Department of Transportation

MEMORANDUM

SUBJECT: ZC Case No. 24-17 – 1619 Massachusetts Avenue NW (Indiana University Campus Plan)

Figure 1 | Proposed Site Plan and Circulation

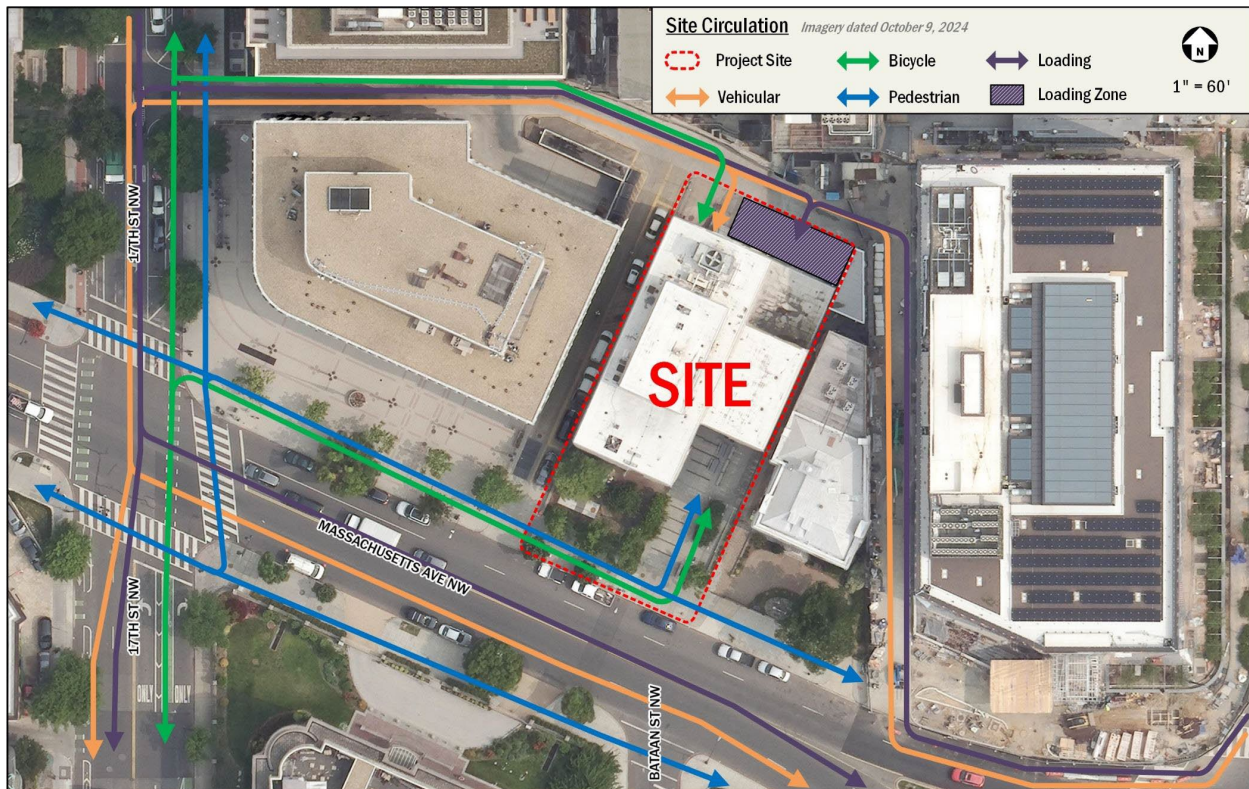
The site will continue to be accessed by vehicles from the rear public alley and by pedestrians on Massachusetts Avenue NW. No vehicle access changes are proposed as part of the campus plan. Bicycle

access will remain in the front of the building as well as via the rear public alley, where new long-term bicycle parking spaces will be provided in the underground garage.

Figure 3 | Existing Pedestrian Facilities

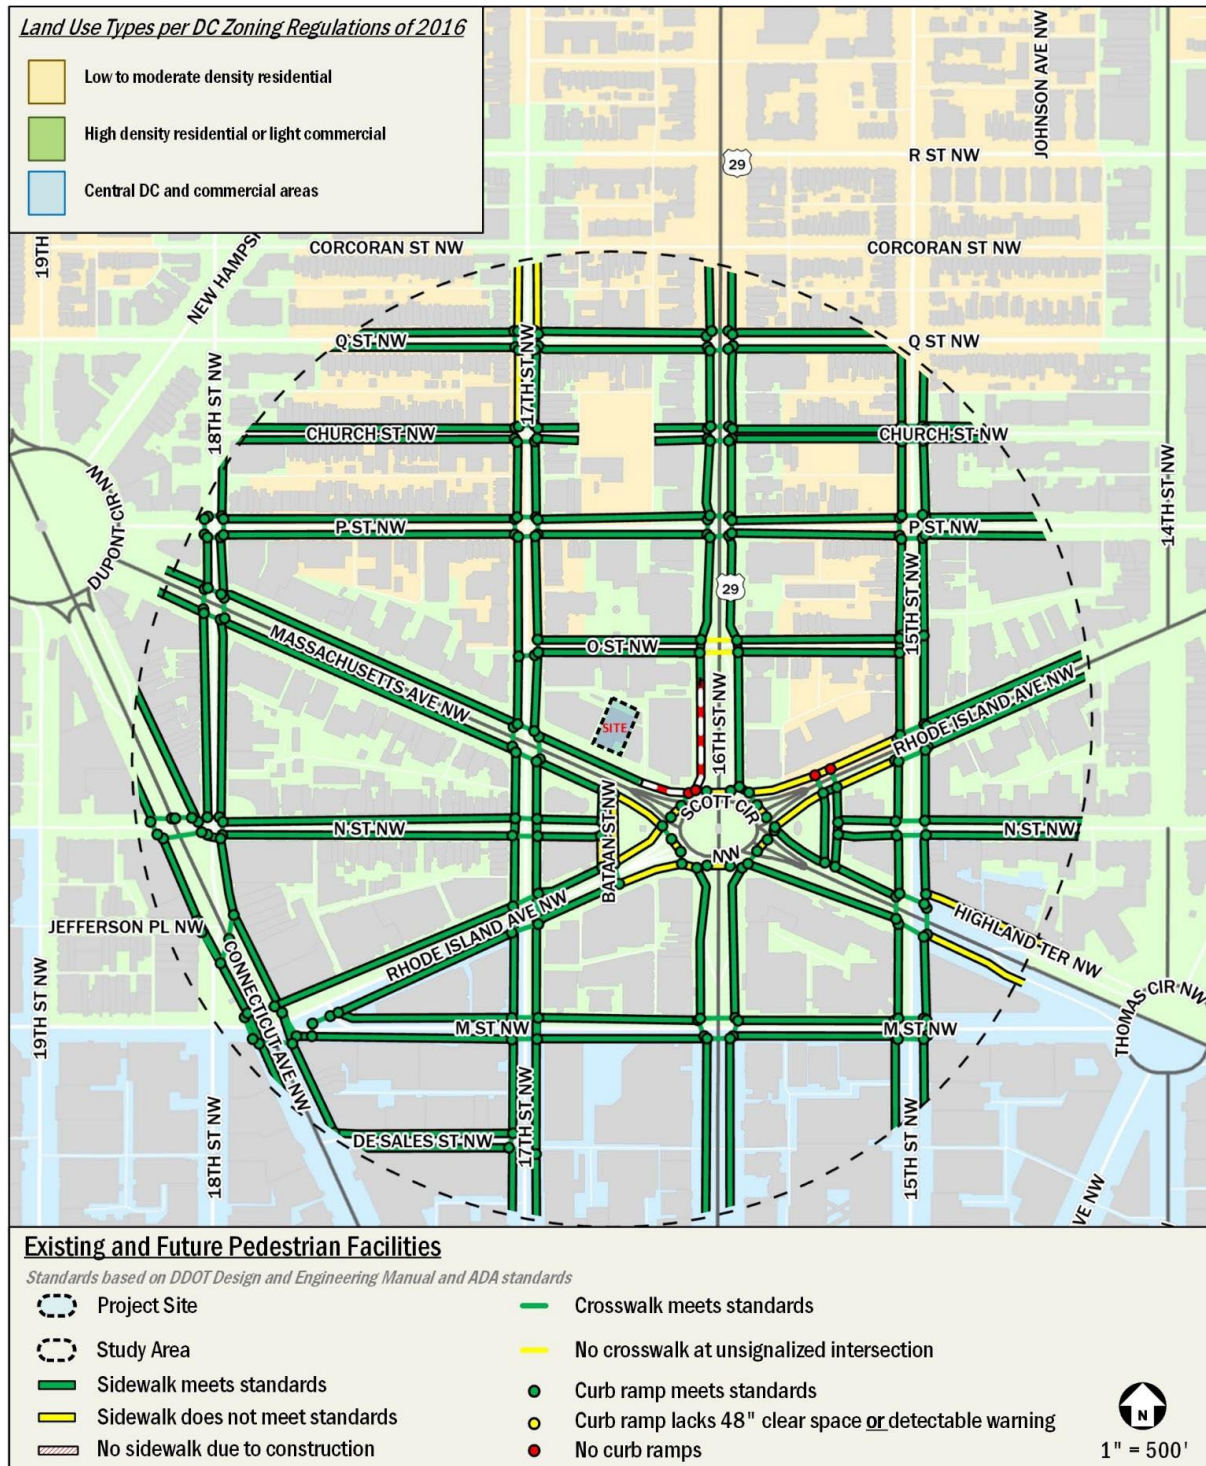
The Applicant’s inventory of existing pedestrian infrastructure, as shown in Figure 3 below, demonstrates that most sidewalks in the immediate vicinity of the site have appropriate widths and include accessible curb ramps. While there are some missing or substandard facilities in the broader area, the existing pedestrian network along major walking routes from the site to shopping, attractions, and the Metrorail station is generally adequate.

Figure 4 | Existing Bicycle Facilities

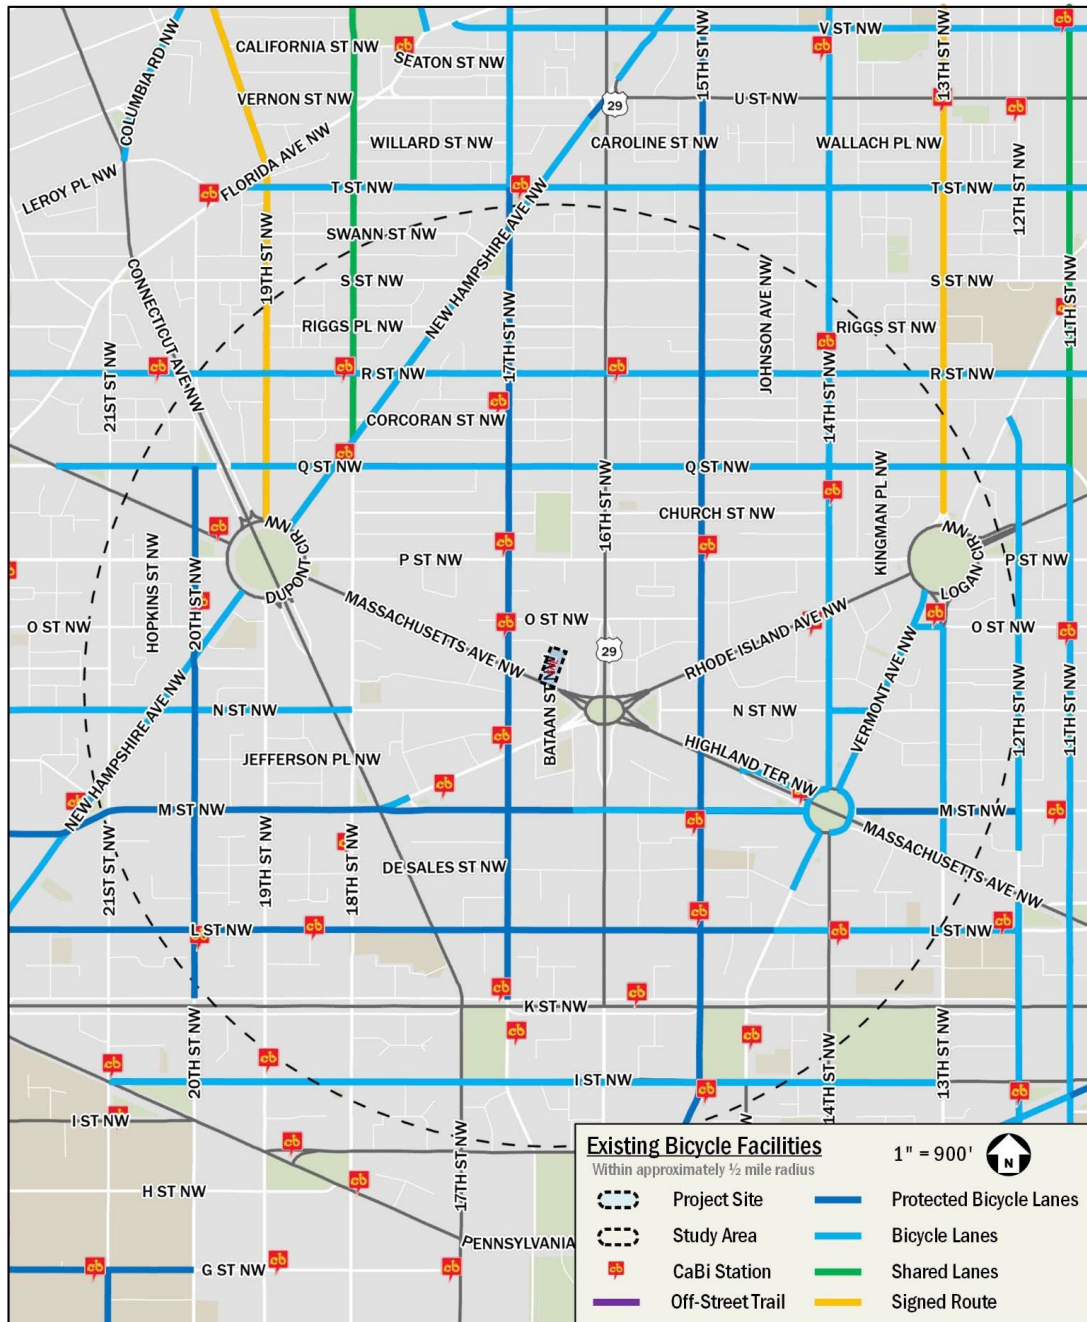
The Applicant will be preserving 38 existing short-term bicycle parking spaces provided via 19 U-racks along Massachusetts Avenue NW, exceeding zoning requirements. As shown on Figure 4 below, the site is well served by bicycle lanes and Capital Bikeshare stations.
